ADSC/WSDOT Joint Meeting
January 24, 2019, 8:30 A.M. – 11:30 A.M.
ADSC/WSDOT Sign-In Form

3. I-90 Kachess River Bridge Project Review

4. I-90 Composite Fill Wall Project Review

6. SR520/I-5 Interchange Project Review

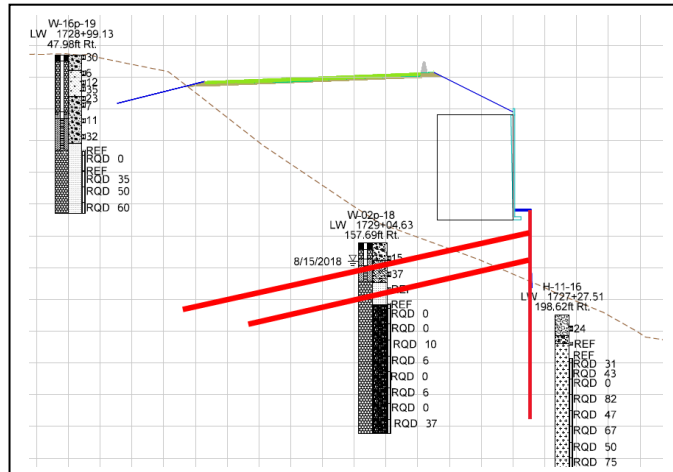
During construction, temp casing will likely be required to support the alluvium, prevent caving, and minimize slurry loss. Because of boulders and cobbles exposed in the alluvium, oscillator/rotator methods are preferred for shaft construction, but conventional construction methods and even telescoping casing could be used. The team suggested detailing required temporary casing to the top of rock. The team asked why there were 6-4ft shafts instead of fewer larger diameter shafts, and the response was the smaller shafts enable construction as close to the creek bank as possible, thus shortening the bridge, and minimizing the needed equipment size. Jeff Minick, WSDOT PE, asked about

production rates. Two shafts per day was originally proposed, but a few members balked at that and felt that one shaft per day was a better number for planning purposes.

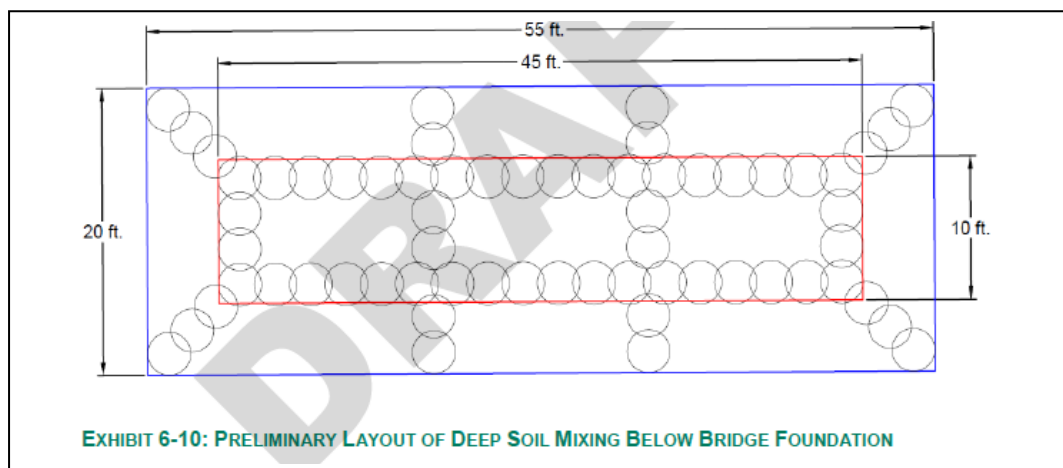
The design team asked about the lagging and facing options. They mentioned that they were thinking of using precast concrete panels for the lagging since the wall is a fill wall. The ADSC team said don't do this. The placement tolerance for the soldier piles has to be very precise with precast panels, and the lead time for panel delivery can be 12 weeks. If the spacing isn't right long delays can easily happen to acquire new panels that fit. Shotcrete facing over temp timber lagging was preferred over the precast panels. CIP concrete could also be used.

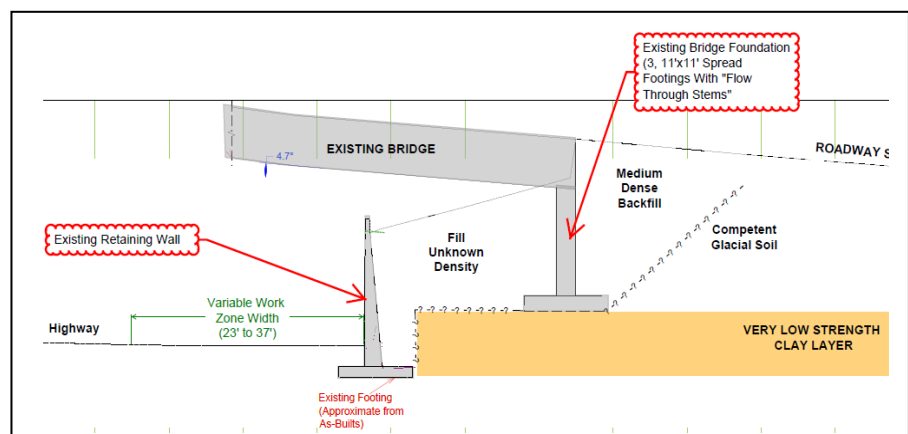
The design team wanted to gain an idea of equipment size. The team thought that a 200,000 ft-pound drill rig would be used, probably something similar to a Bauer BG26 or Watson 4300. Rigs of this size are typically 40-ft in length, crawler mounted, and weigh around 150 kips.

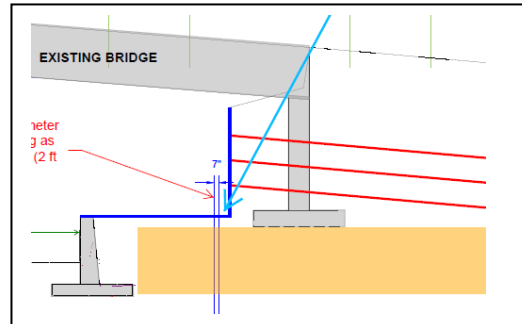
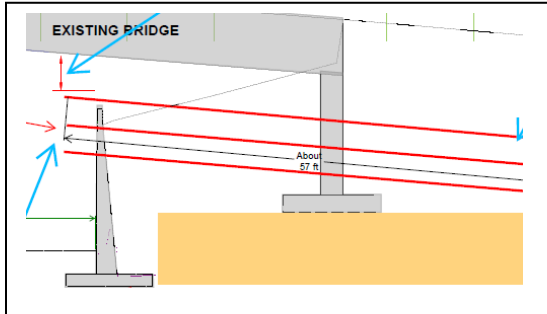
There is 4 ft clear from the bottom of the box girder bridge to the top nail. The ADSC team thought that was acceptable. Nails would be inclined at about 5-deg. The ADSC thought that was also doable. The ADSC team thought it would be better to remove a portion of the current wall, and have a temporary slope rather than drill through the wall. The ADSC thought that the drill would most likely be supported on an excavator boom and would have a mast length of about 20 feet. They wanted to make sure that there was enough separation from 520 to account for the boom length and minimize bar splices. The current work zone is tapered, 23 feet wide at one end and 37 feet wide at the other. The 23 feet is probably too tight, and will require temporary lane closures. The team should consider 30 ft as the minimum width needed. A major concern was the containment of fly-rock during drilling. Blankets or shielding of some sort will likely be needed to prevent fly-rock from hitting 520 traffic. Injection Bore Anchors were proposed as a good solution to solve rod length issues and fly-rock issues. Another alternative that was suggested was to do low clearance soil nail wall construction on a bench above the existing wall directly adjacent to the abutment. They need about 15 ft for a bench width, but there may not be enough vertical clearance to accomplish this. Face stability is a concern with this option given that the end slope fill is likely not well compacted.

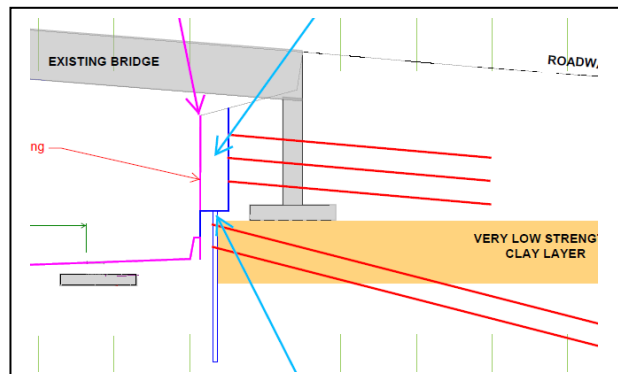
Further complicating the design of this wall, is the Seattle clay that is present beneath the bridge footing. The modeling that the geotechs have completed shows that the bridge will not be stable when the clay is cut into. Additional shear elements are needed to prevent strain in the clay, loss of soil strength, and global failure. Seven inch diameter, vertical, micropiles are being proposed. The micropiles are depicted in the right most figure above. Because of the OH clearance, casing joints in the micropiles will be necessary. The ADSC team did not think that micropile installation would be an issue, provided they did have 10 ft or more of vertical clearance, casing joints, and at least 18-inches clear to the face of the soil nail wall. After the

micropiles are installed, nailing and excavation would continue. There would probably be two rows of long nails that would also help restrain the tops of the micropiles. As shown in the image to the right.

The ADSC recommended trying to maintain at least 2 feet of separation between the lowest nail and the excavation base. Where there is a bench between micropile wall and upper soil nail wall, it was recommended to place a 1:1 shotcrete wedge to make the bench not habitable.

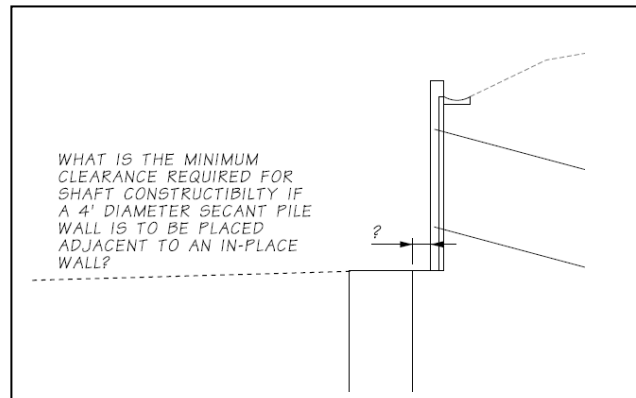
Switching topics, the Design team presented a second issue where they needed to construct cylinder pile wall's shaft next to an upper soil nail wall. The ADSC recommended that they maintain 3 ft clearance between edge of shaft and wall face.

In another variation, rather than doing a soil nail wall on top, it was postulated to just do a cylinder pile wall, but the upper soils have drainage concerns. The design team asked about using permeable concrete as lagging shafts with every other shaft being structural. The ADSC discouraged relying on permeable concrete long term. More conventional drainage construction like trenching in a drain behind the wall and then daylighting the drainage through weep holes or a drain tile was recommended instead.

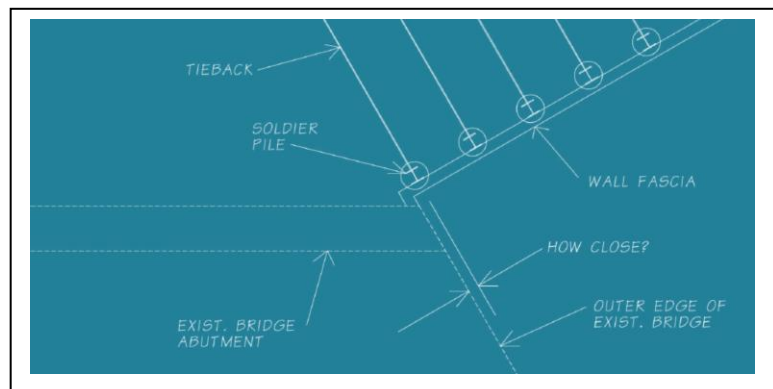
The last issue on this project is related to soldier pile shoring with anchors next to a bridge abutment. The ADSC recommended rotating the beam or moving the beam 3 feet from the corner. Moving the beam would mean that lagging would need to be attached to the bridge by some means.

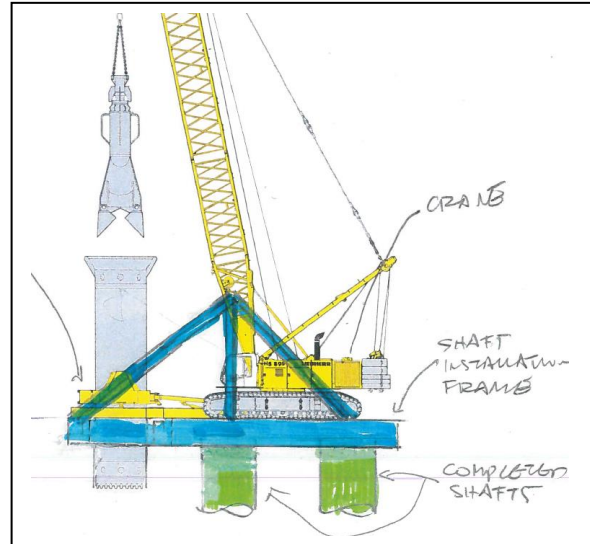
This will be a 9 span viaduct structure. Each pier will have two 10 ft diameter drilled shafts. Diameter is controlled by the column architectural requirements. Shafts will be 50 feet in length, roughly. Soils consist of gravels and sands that are poorly graded with

significant cobbles. ADSC thinks temporary casing is a good idea so required casing will be used. ADSC was also in favor of requiring the oscillator for this project.
